BUREAU OF LAND MANAGEMENT

April 10, 2013

RE: COMMENTS ON DRAFT FINAL WATER QUALITY CERTIFICATION FOR THE EAGLE MOUNTAIN PUMPED STORAGE PROJECT, FEDERAL ENERGY REGULATORY COMMISSION PROJECT NO. 13123

Figure 1: Approximate Location of the Chuckwalla Valley Groundwater Basin and Proposed Renewable Energy Projects on Federal Lands

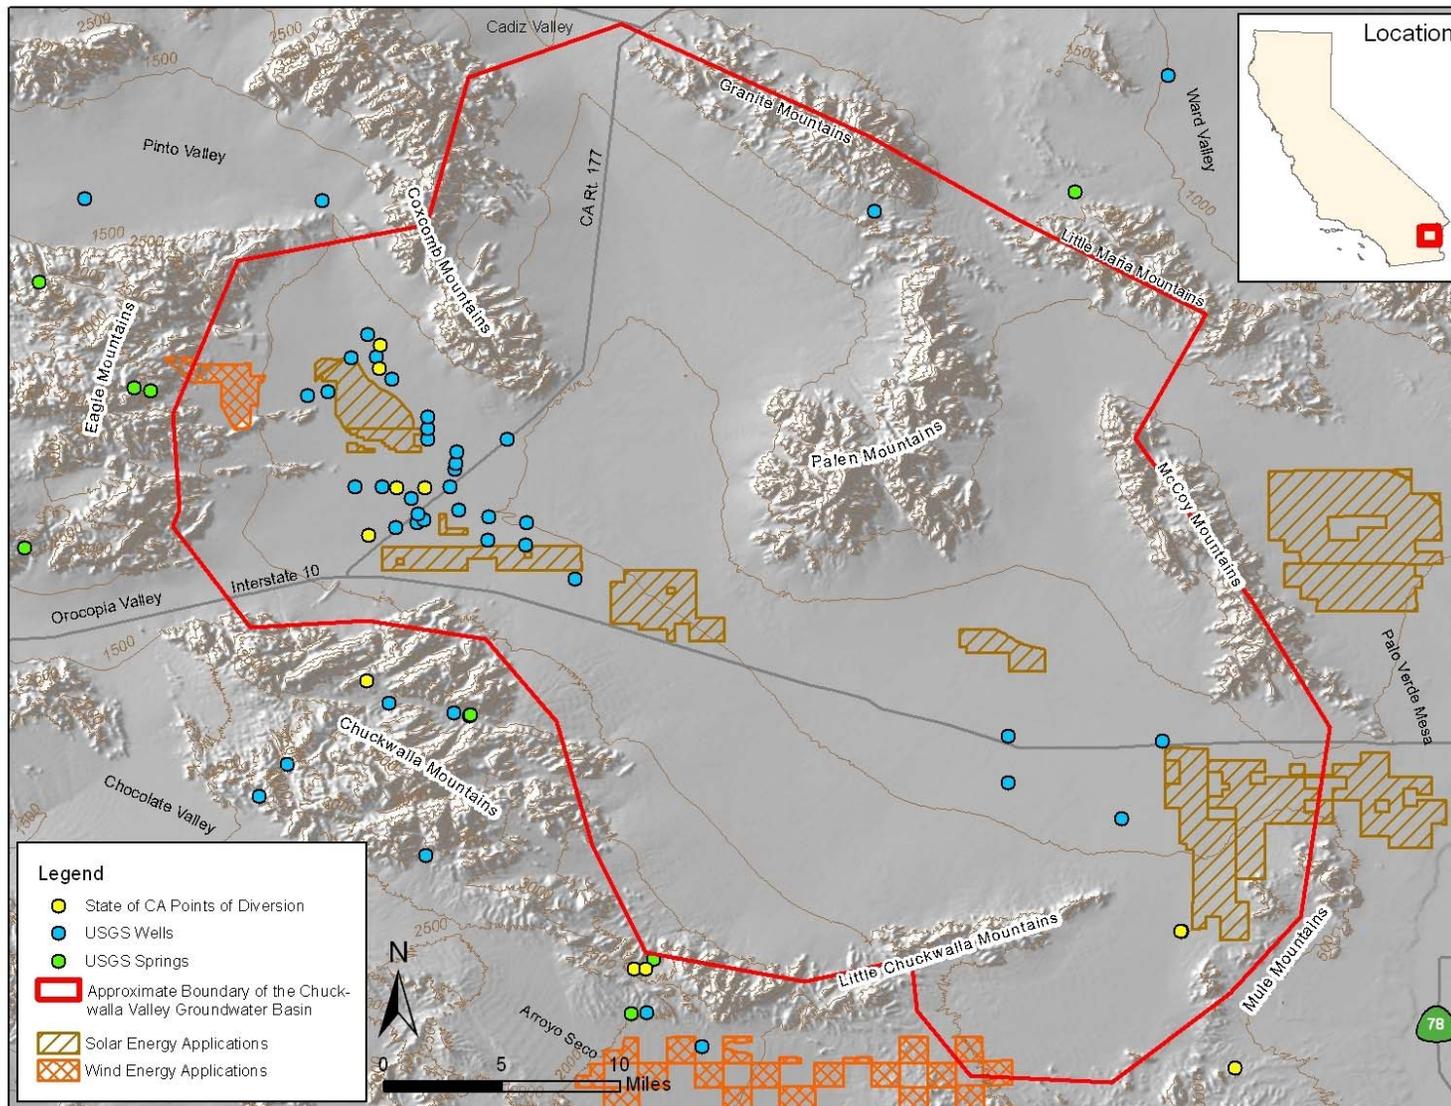
nine additional authorized and proposed projects involving Federal lands in the Chuckwalla Basin are currently being evaluated by the BLM (Figure 1). California's Groundwater Bulletin 118 (CA-DWR, 2003) identified this basin as having insufficient information available to adequately determine recharge, outflow, or a safe yield for groundwater development.
